**LEBANON PLANNING BOARD
JANUARY 10, 2022 - 6:30 PM
COUNCIL CHAMBERS, CITY HALL OR
REMOTE VIA VIRTUAL PLATFORM
LEBANONNH.GOV/LIVE**

**Mount Support Development, LLC
(applicant) and Sylvia D. Lahaye
Revocable Trust & Pat Lumber
Jack, Inc. (property owners), 402 &
392 Mount Support Road (Tax Map
24, Lots 9 & 10), zoned R-1
PB2021-33-SPR**

Staff Memorandum – PB2021-33-SPR – *con't from 12/13/21*

SITE LAYOUT PLAN (1 OF 2)

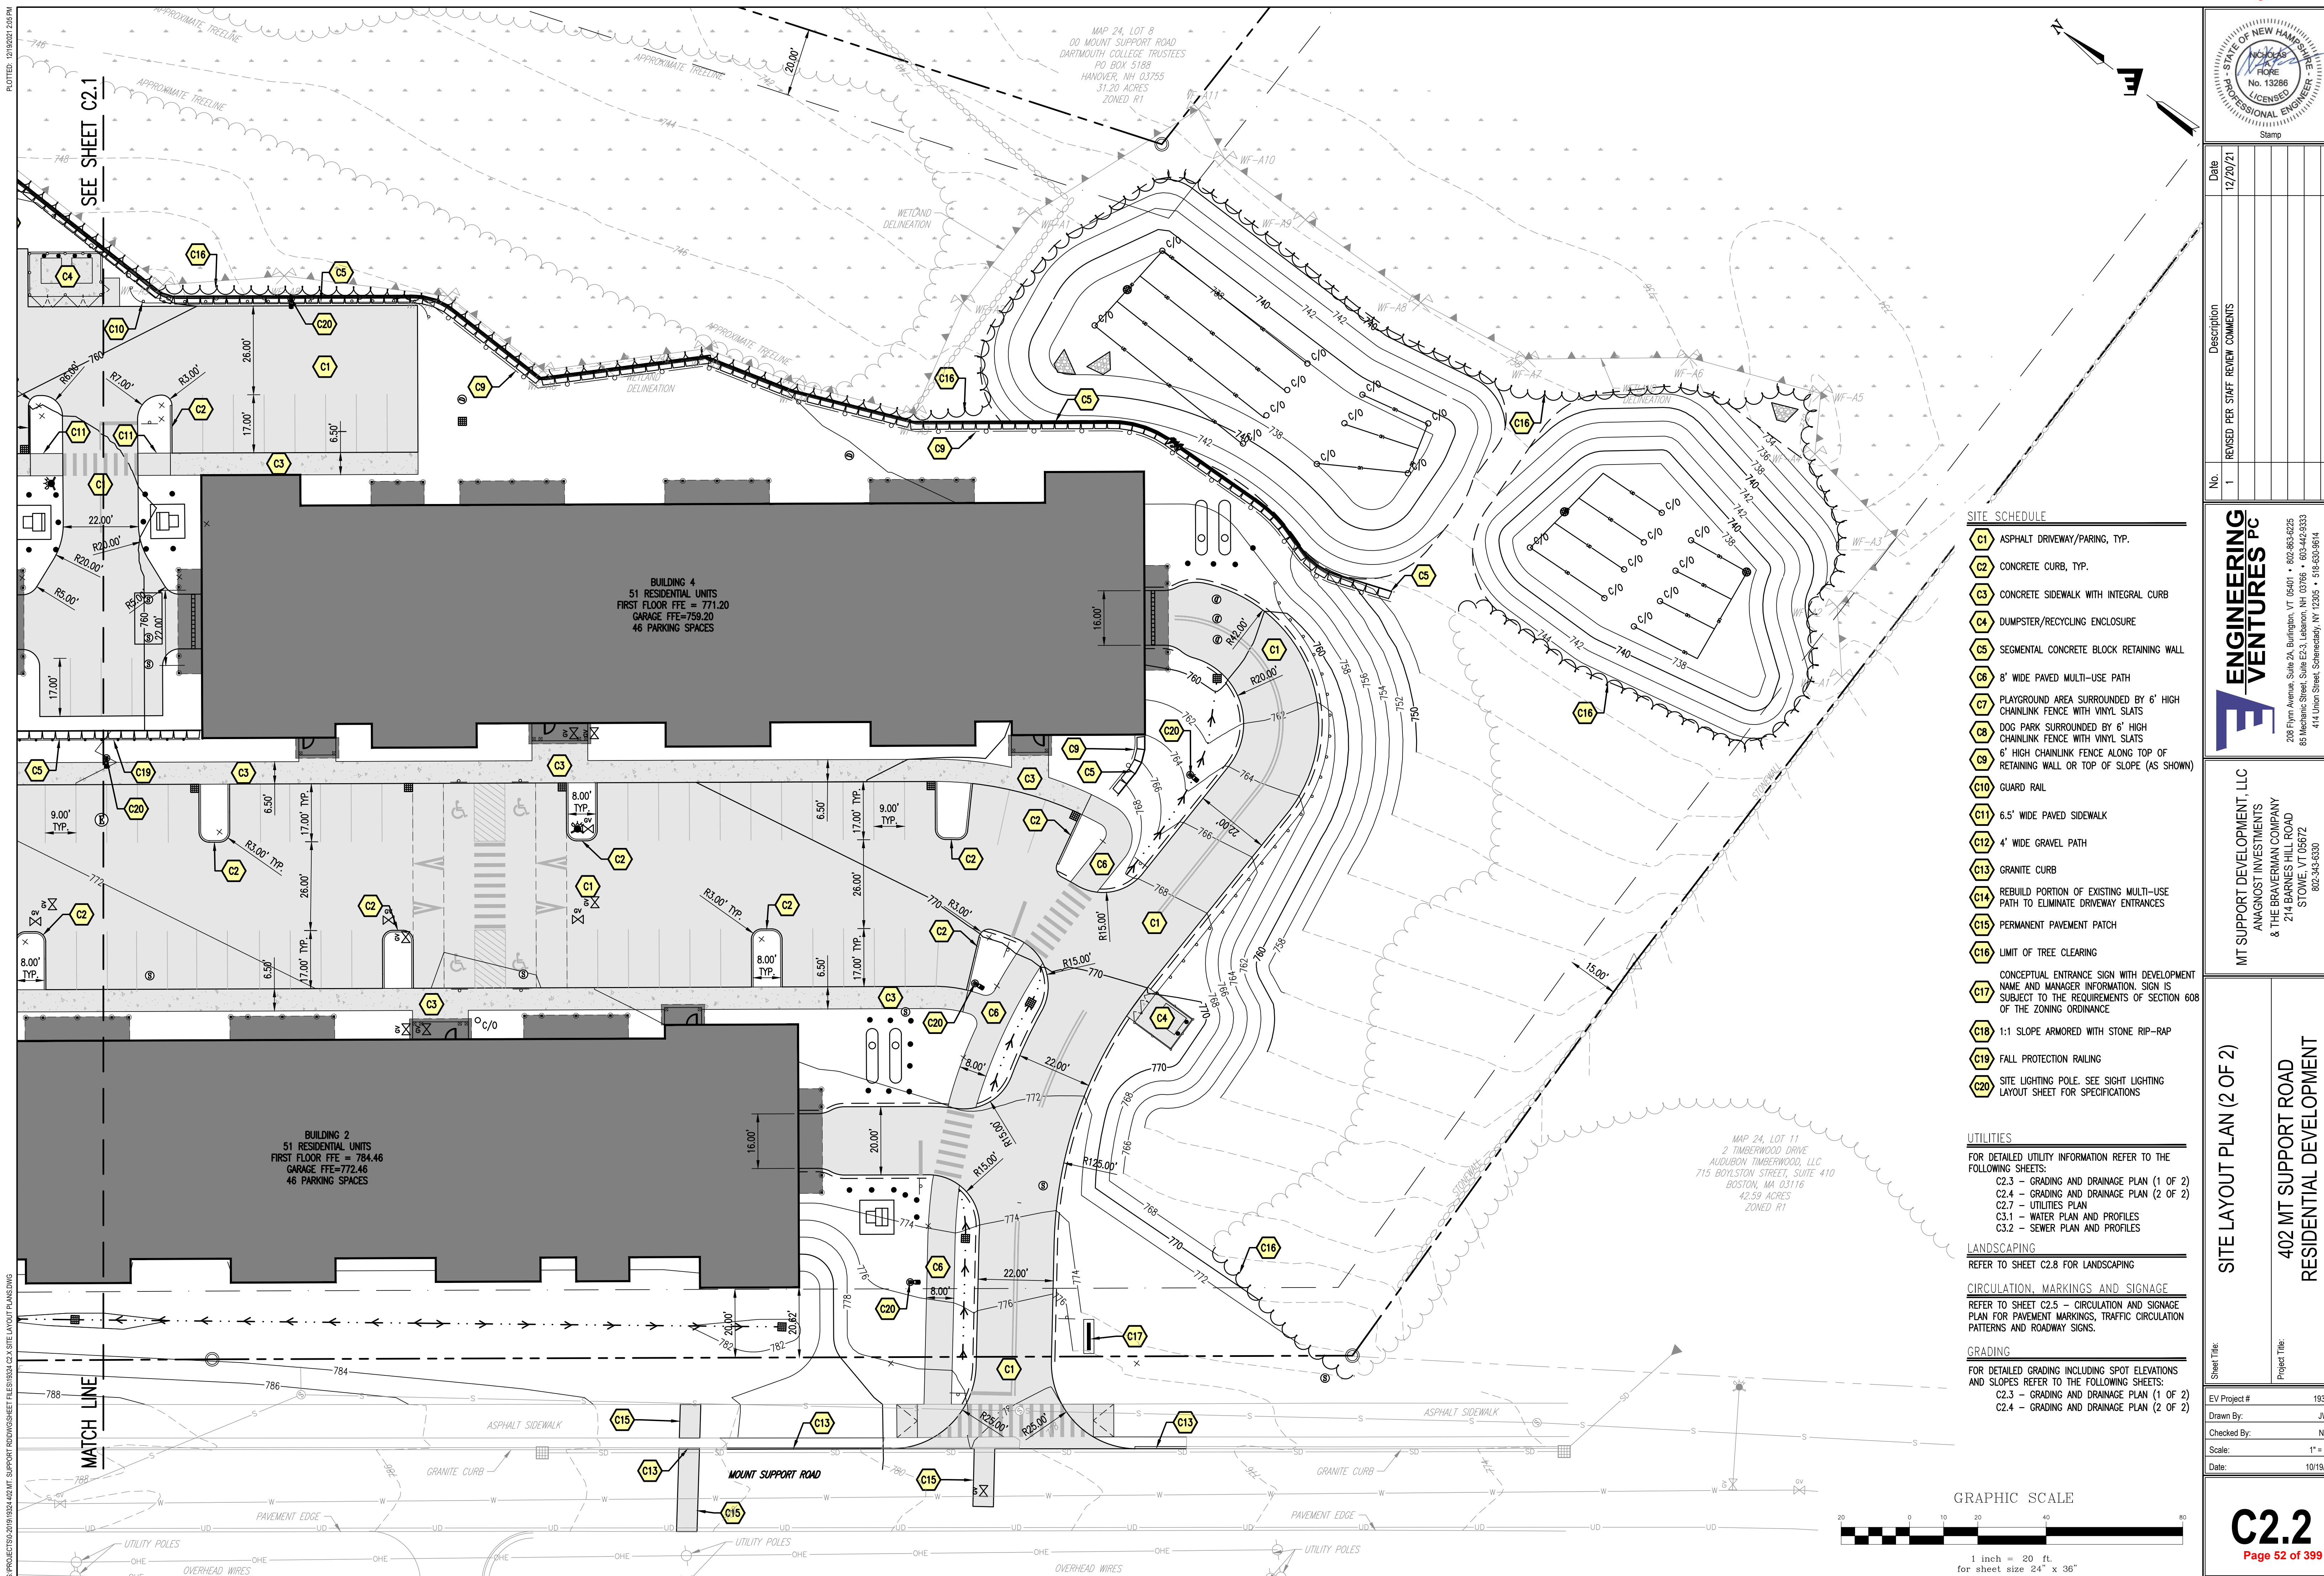
4. Based upon our review of Sheets C2.1 and C2.2 (Site Layout Plan) we offer the following remarks:
 - The drawings indicate numerous lengths of proposed retaining wall are planned. We recommend the drawings be expanded to specify safety rail of an appropriate type and dimension is to be installed at all locations where such accommodation is required pursuant to applicable building code requirements. We further recommend corresponding construction details of rail installation be provided on the final drawings.

- Sheet C4.2 of the revised plan set includes detail for fencing and railings.
 - The drawings identify areas of the site to be reserved for playground and dog park amenities. Notes provided on the drawings suggest these areas are to be enclosed with fencing. We recommend the drawings be expanded to specify fence type and height as well as surface preparation within fenced interiors.

S:\PROJECTS\2019\1524\402 MT SUPPORT RD\DWGSHEET FILES\1524 C2.9 LANDSCAPE PLANNING

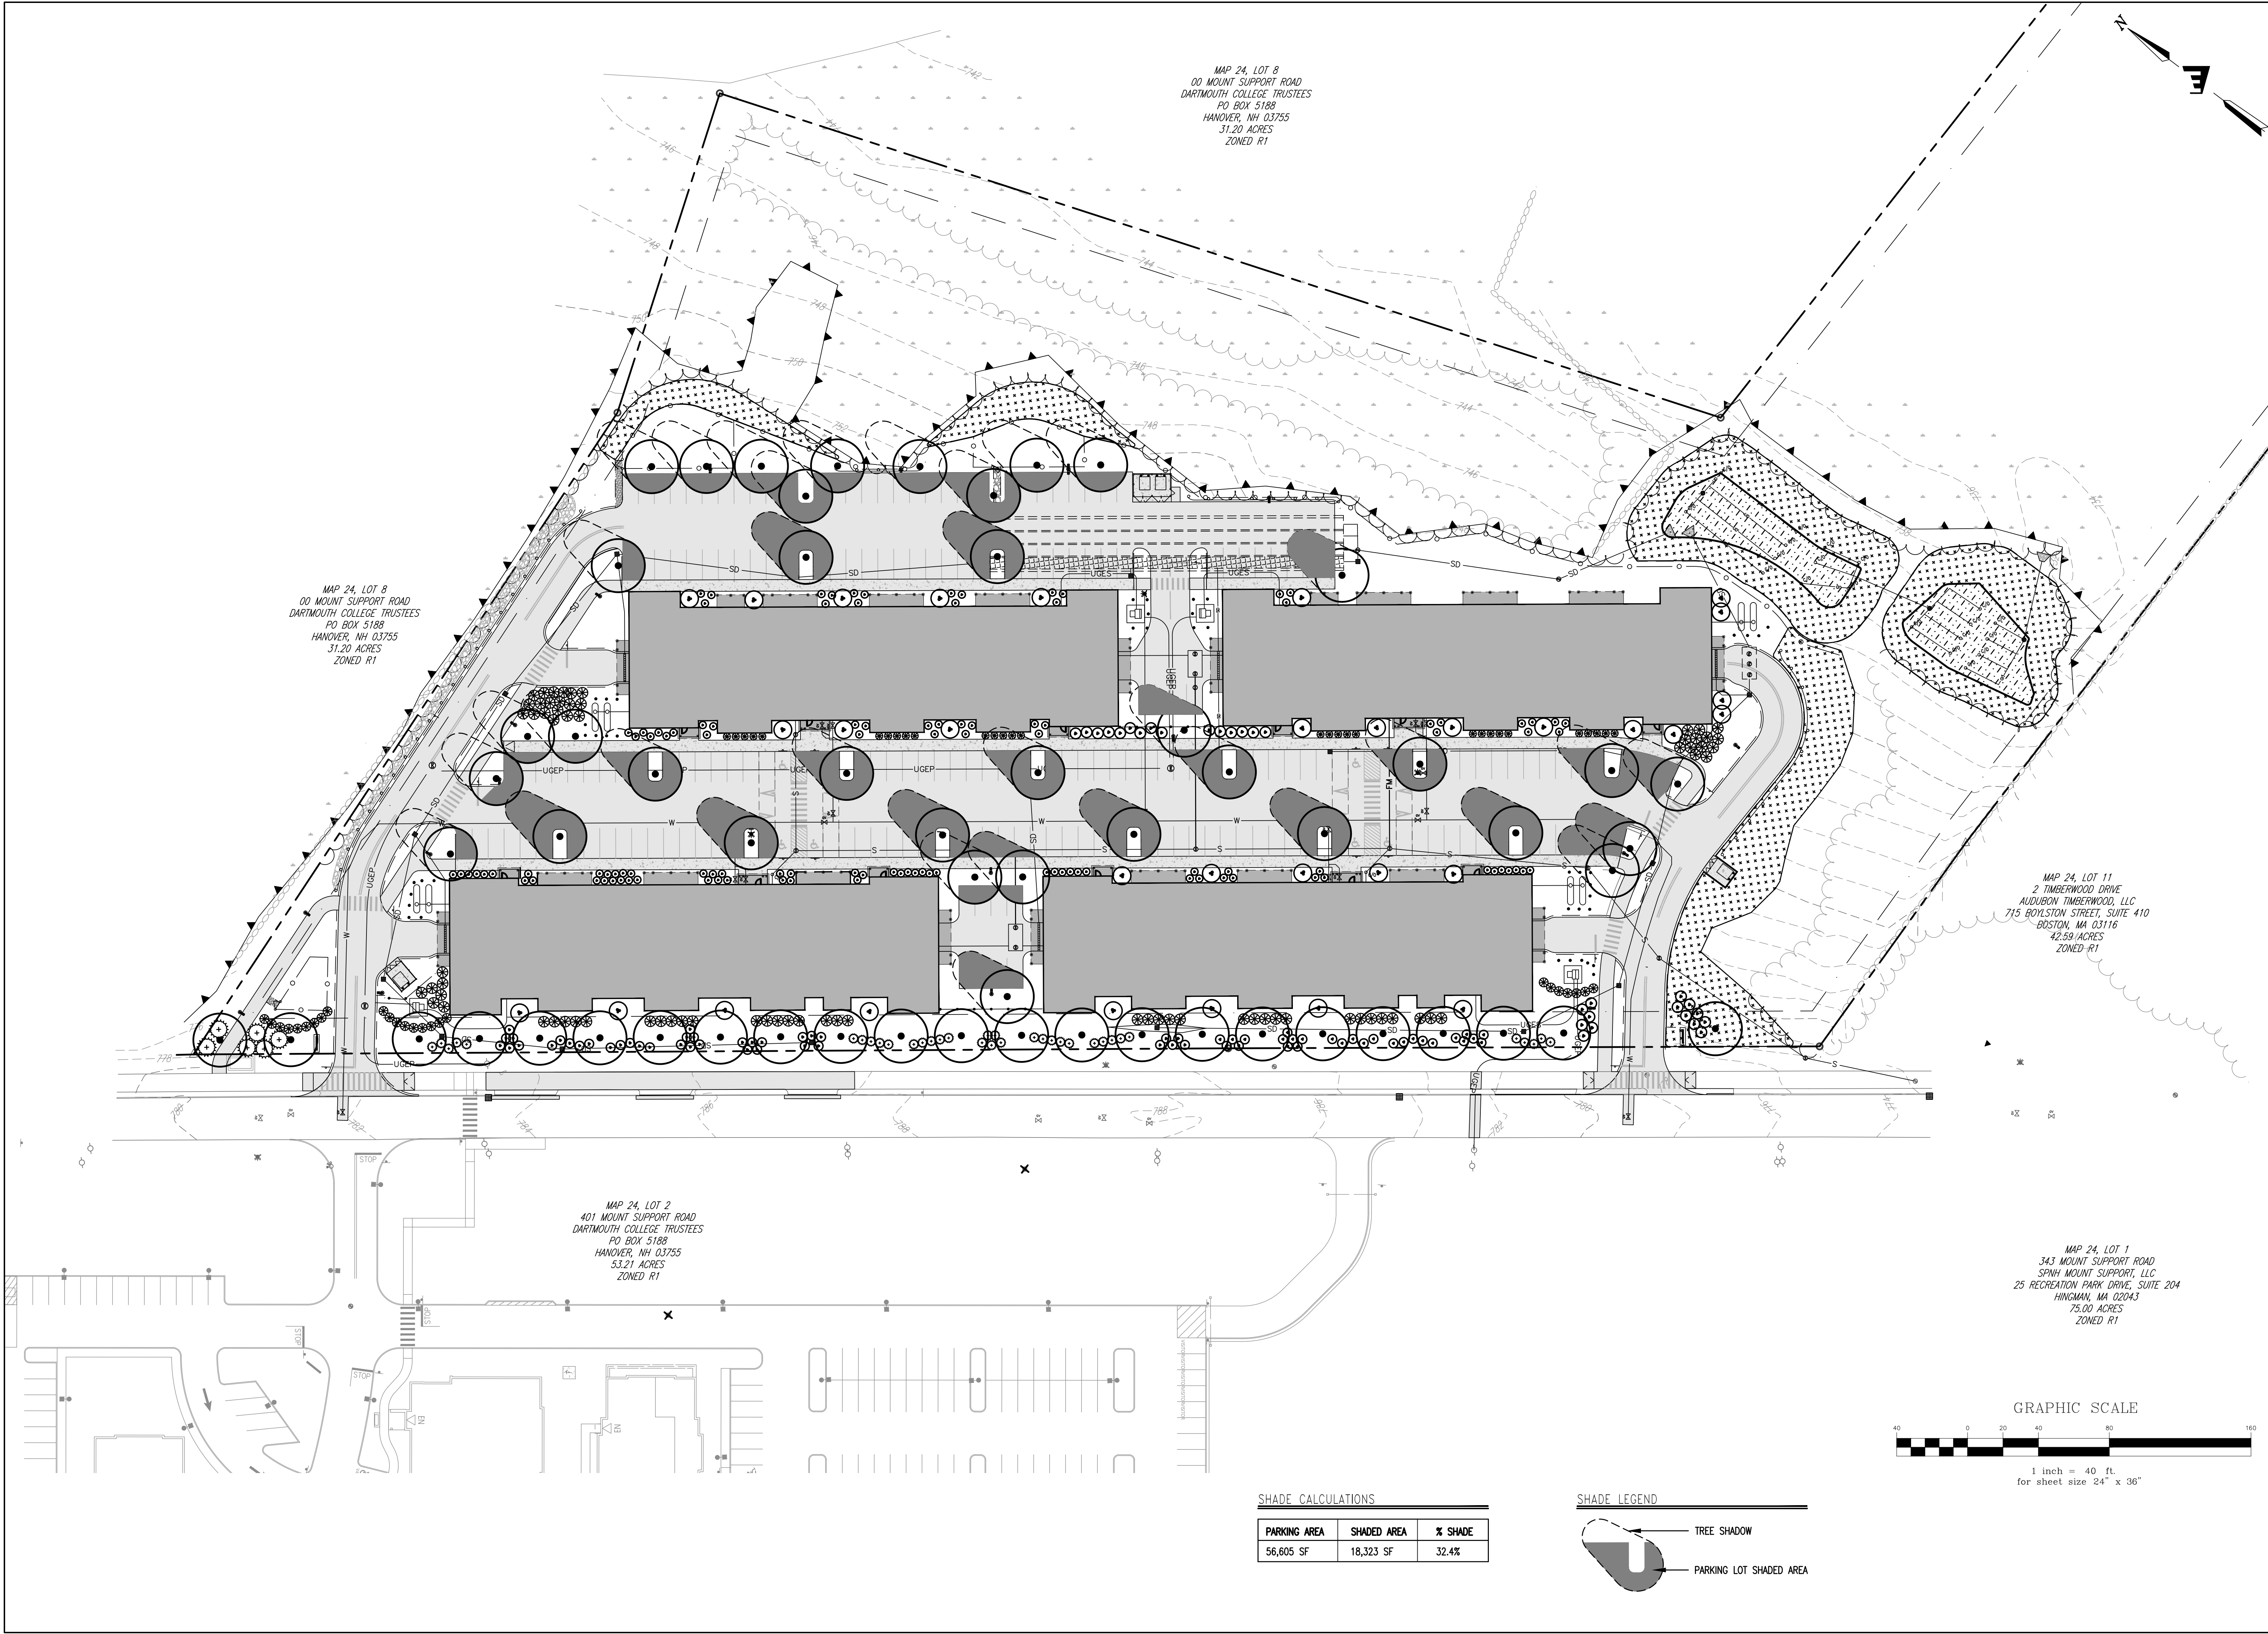
13. We recommend Sheet C2.8 (Landscape Plan) be expanded to include notes and specifications capturing applicable requirements of Section 6.2.H of the SPRR's regarding both workmanship and materials to be incorporated in the planned landscape installation as well as future maintenance of the same.

- Sheet C2.8 of the revised plan sets includes notes regarding both workmanship and materials to be incorporated in the planned landscape installation as well as future maintenance of the same.

S:\PROJECTS\2019\1024\402 MT SUPPORT BUILDING\2021\1024\1024-10 EROSION CONTROL PLAN.DWG

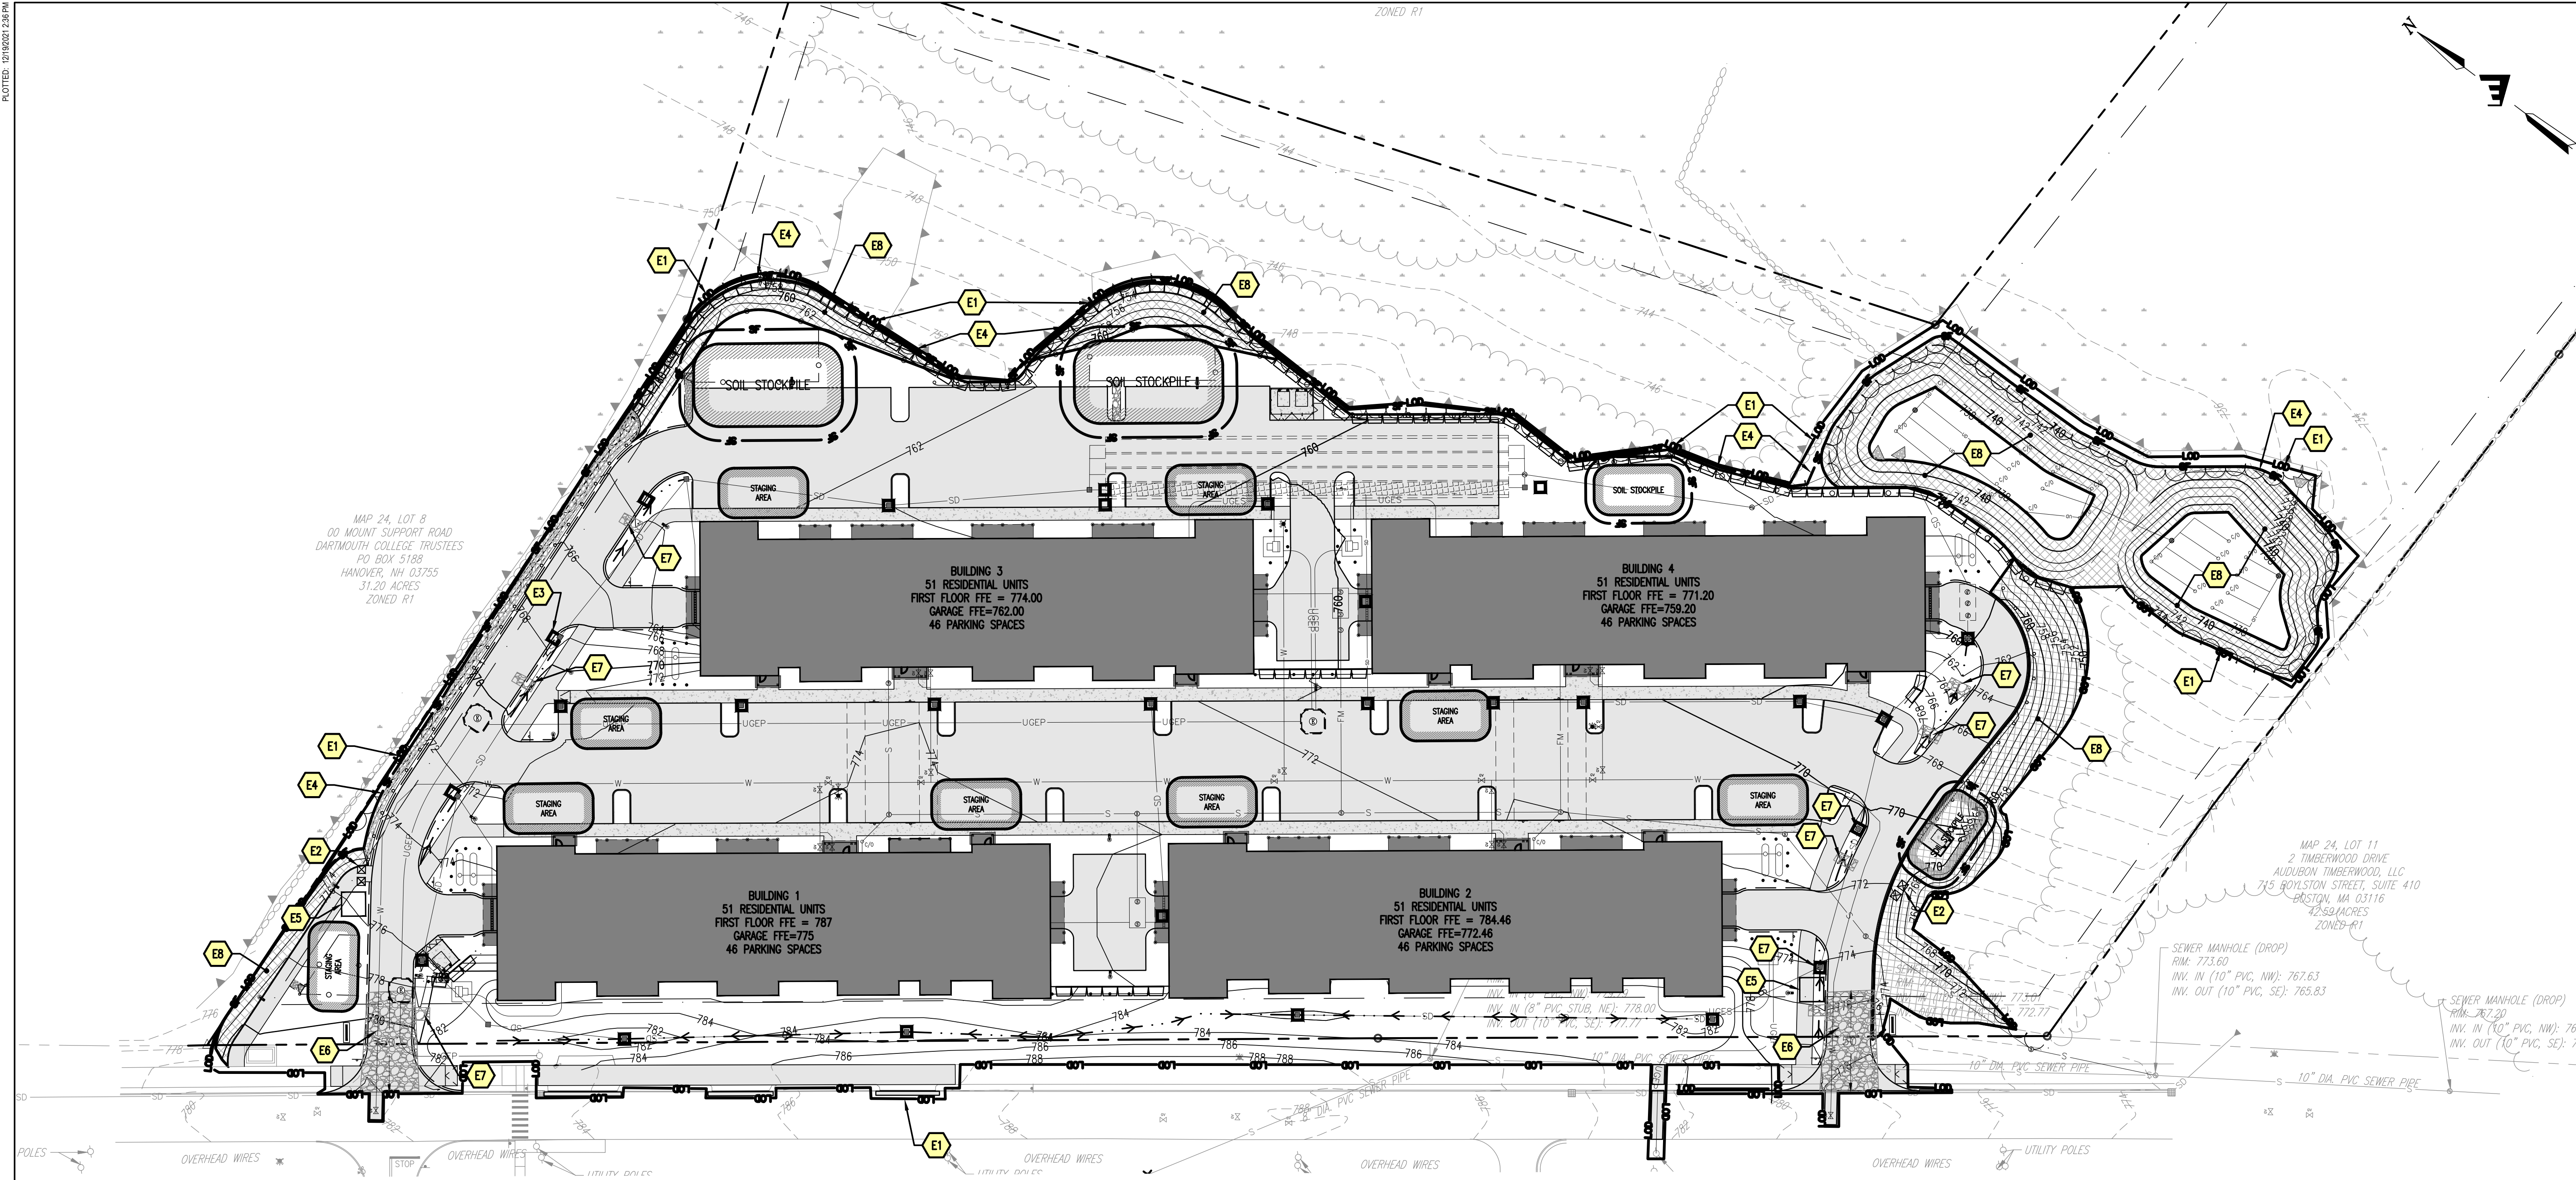
14. Sheet C2.10 specifies intent to install fabric silt fence as a primary erosion and sedimentation control practice around the perimeter of the project work area. Given immediate proximity of planned earthwork and site improvements to adjoining land of others (northerly site boundary) and jurisdictional wetland (easterly limits of work) we recommend the design engineer consider specifying use of mulch berm, in lieu of fabric silt fence, for improved durability and performance throughout the duration of construction.

- The revised plans now use natural fiber coir rolls instead of silt fence. They require a smaller footprint than a mulch berm.
15. Based upon review of planned accommodations for sanitary sewer service provided on the project plans (See Sheet C3.2) we offer the following remarks:
